Network Video Recorder

Version: V4.1.50 build180227

Release Note

(2018-03-20 External)

System – System service – Stream Encryption

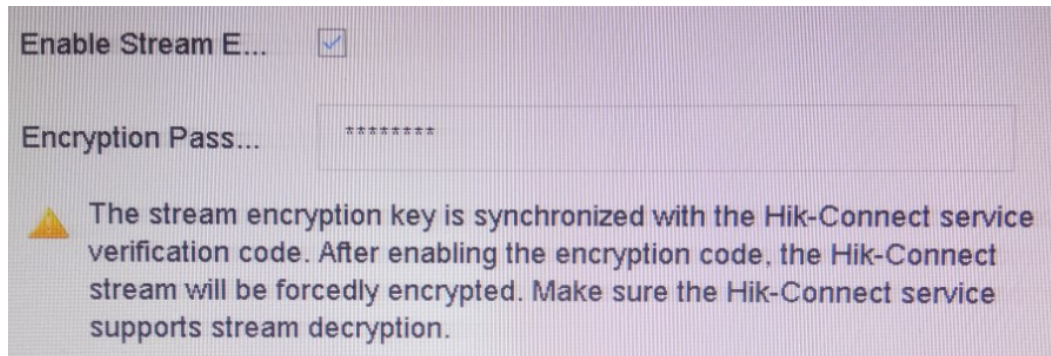
2. 【Stream encryption】

(1) Once stream encryption is enabled, the output video stream will be encrypted by AES.

(2) The key remains the same as the HC encryption key, so one of them is modified and the other one is modified synchronously.

(3) Up to 16 channels encryption is supported.

Camera – Camera – IP camera

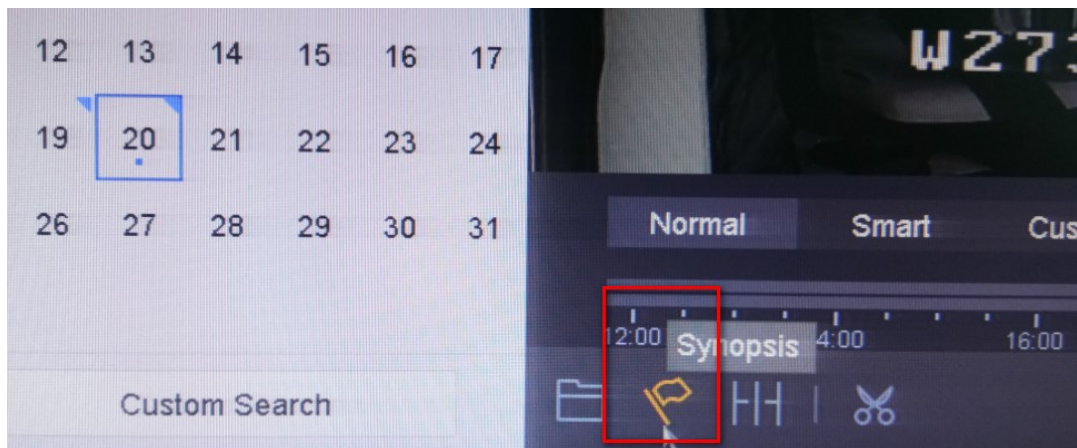
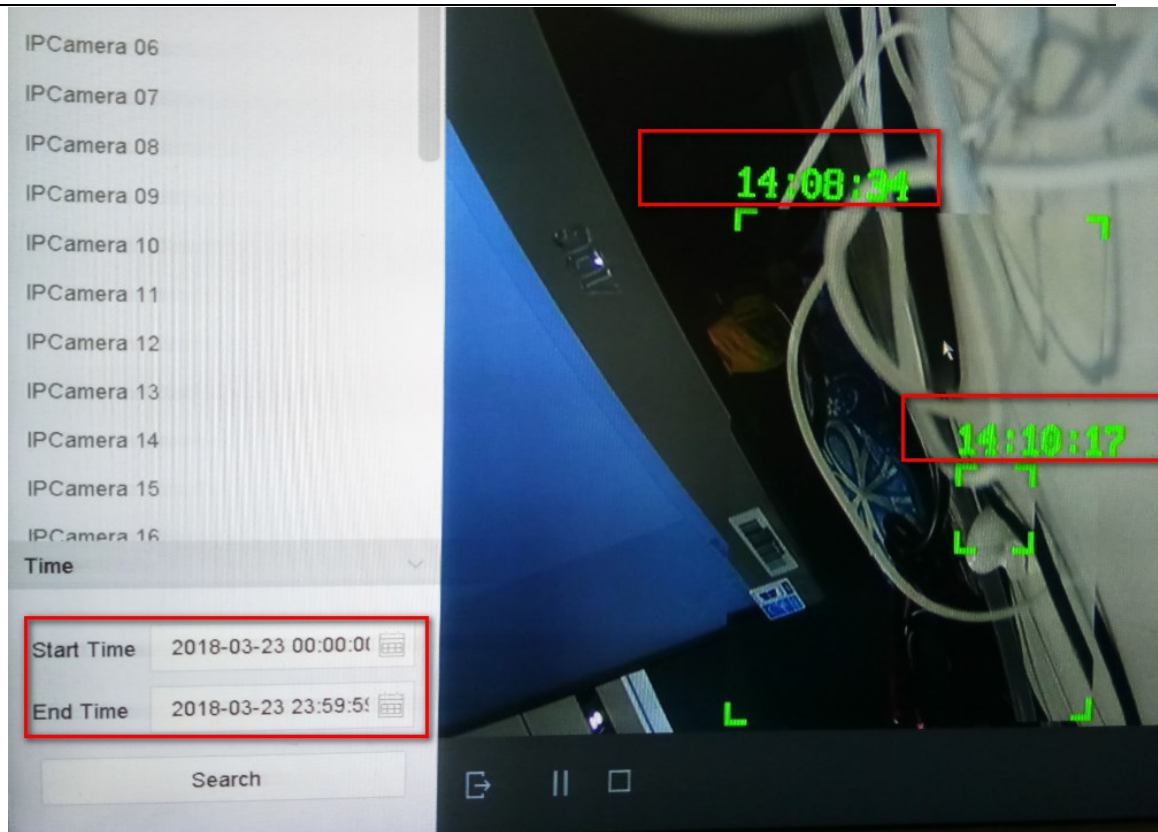
7. 【POE】

(1) NVR that has PoE port is able to add IPC automatically when IPC connects with switch and switch connects with one PoE port of NVR.

(2) The PoE channel can be enabled or disabled.
